# City Planning Department

To: Cranston City Plan Commission  
From: Beth Ashman, AICP – Assistant Planning Director / Administrative Officer  
Date: August 29, 2024  
Re: **Dimensional Variance @ 173 Niantic Avenue**

**Owner:** Frank Zincone  
**Applicant:** Ercilio Electro Auto Inc.  
**Location:** 173 Niantic Avenue, AP 7, Lot 2204  
**Zone:** M-2 (General Industry)  
**FLU:** Industrial

1. To allow the enclosure of the 2,784 ft<sup>2</sup> (60' x 47') canopy added to the auto-repair facility in 2021. The enclosure would encroach into a front and side setback on a double-fronting lot. The canopy received a variance in 2021 for these same encroachments. [17.20.120 – Schedule of Intensity]

## STREET VIEW (Niantic Ave Facing West)

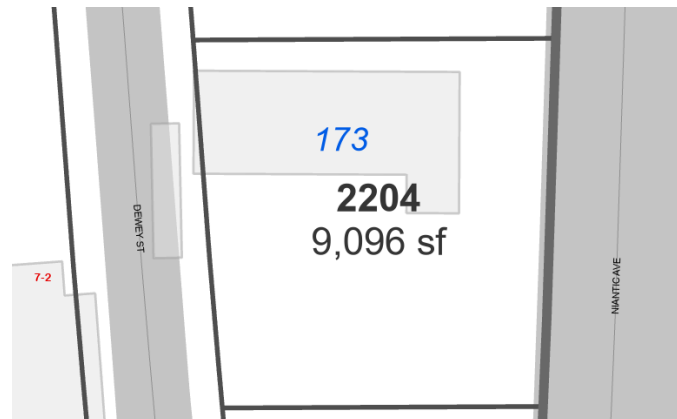
Google Streetview. Accessed 8/27, 2024. Staff confirmed that the movable letter sign captured in this photo has been removed as of 8/26/2024.

## STREET VIEW Dewey St Facing East

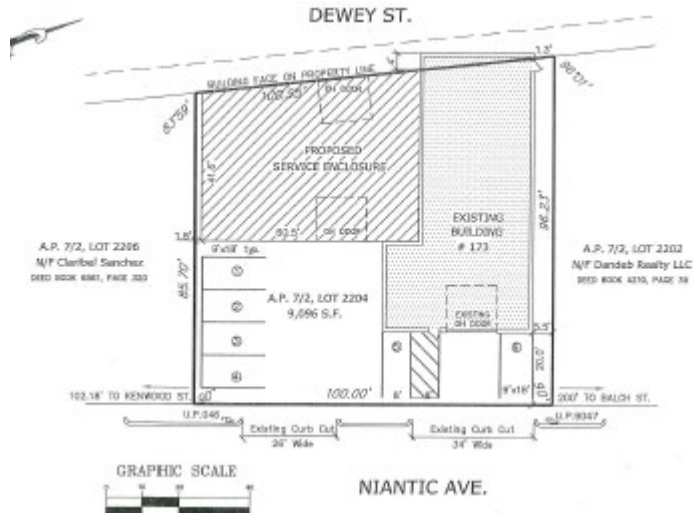
Source: Cranston Planning Dept Photo 8/26/2024. This view looking north on Dewey Street. The red box highlights fence and storage items in the public way.

# SITE PLAN

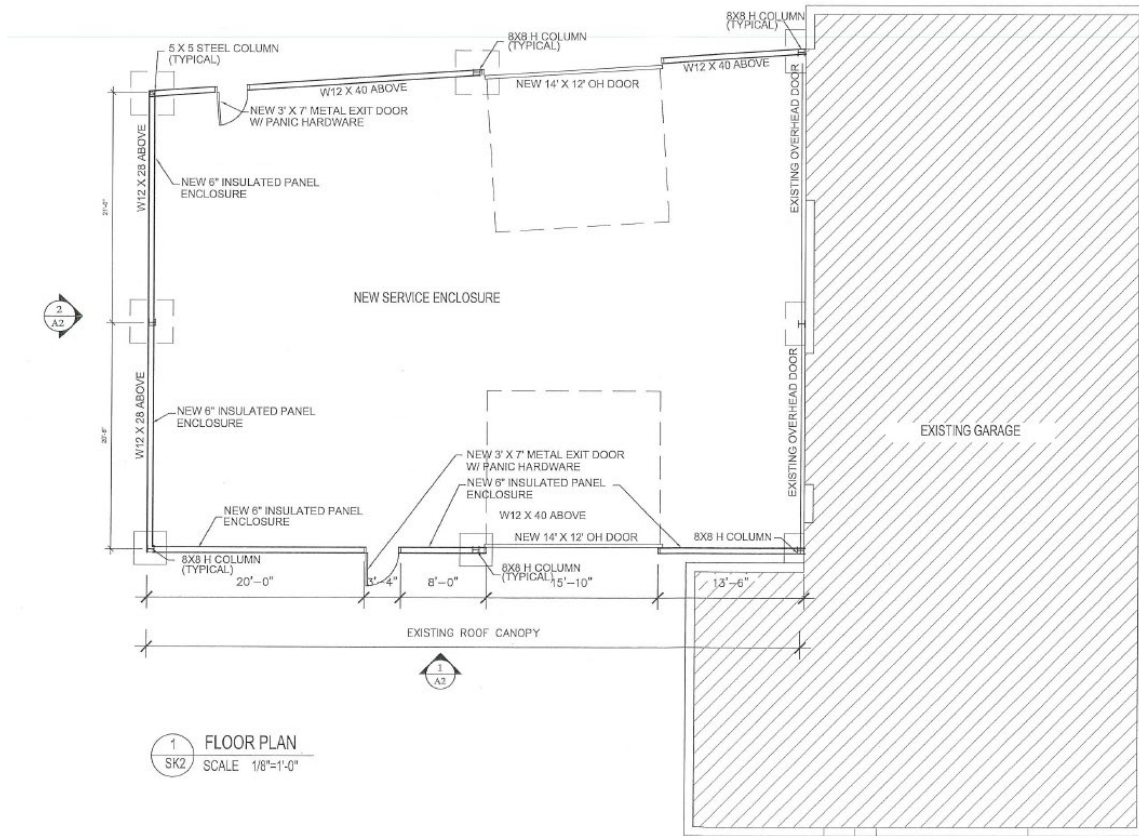
11. The site plan shows 6 off-street parking spaces, which meets city off-street parking requirements for industrial uses. On August 27, 2024 and on the date of the Cranston Aerial Photos 2024 March three of the six spaces were occupied by a metal container and material storage. In this state the property does not provide the required off-street parking.

The service enclosure would be 0' from the "front" property line on Dewey Street, which has a 40' front yard setback and 8.3' from the southern interior side lot line which has a 20' setback in M-2 zoning. The service enclosure replaces the open roof canopy approved in 2021. As the service enclosure is in the same location as the service canopy, it can be said to not create further incursion into required setbacks.

The site plan shows 6 spaces, which meets the City's off-street parking requirements for industrial uses. However, three of the spaces are occupied by material storage.

1. *The six parking spaces shown on the SITE PLAN SHOWING PROPOSED SERVICE ENCLOSURE FOR ERCILIOS ELECTRO AUTO by Walter P. Skopupski, Surveyor dated 7/1/2024 will be available for parking and not used to store materials from one day to the next.*
2. *Trailers, cement bins, and stored materials be removed from the property frontage on Dewey Street and the area cleaned up before a certificate of occupancy can be issued for the new enclosure.*

# ELEVATIONS

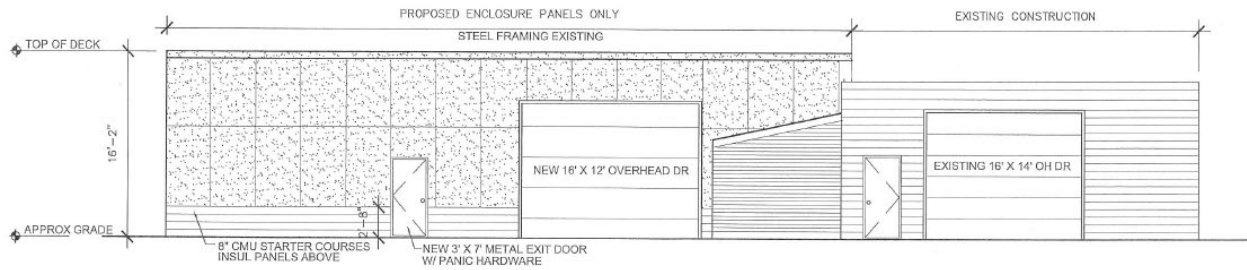
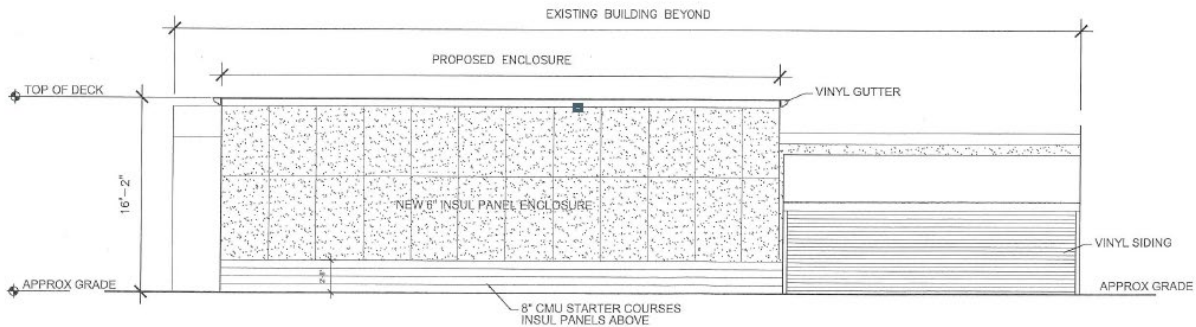
The service enclosure is proposed to be 16' 6" high. The building is 14' high. Both comply with the 35' height limitation.

The proposed overhead door facing Dewey Street will require the removal of trailers, materials, and debris obstructing the frontage with Dewey Street. It would not be acceptable to install the new door to provide access to Dewey Street as a location for storage. For these reasons, **staff finds that that the expansion would not be out of character with the area as long as all trailers, materials, and debris are removed from the Dewey Street frontage.**
